From beginning of September 2006 the impeller screw and washer have been changed for:

- **Proline** Minette-Major, Midi
- **MSHA** Minex-Major, Master H, Midi

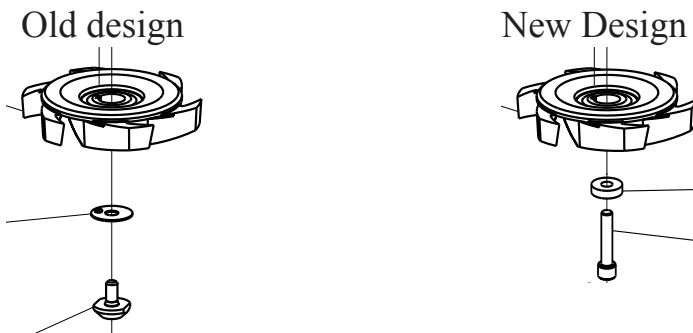
The new screw and the old washer are not compatible with each other or vice versa. Therefore both screw and washer have to be changed at the same time. The old screw (140171) and washer (133147) will be available as spare parts.

Note: The new screw is prefabricated with loctite, after dismantling it must be treated with loctite before reassembling.
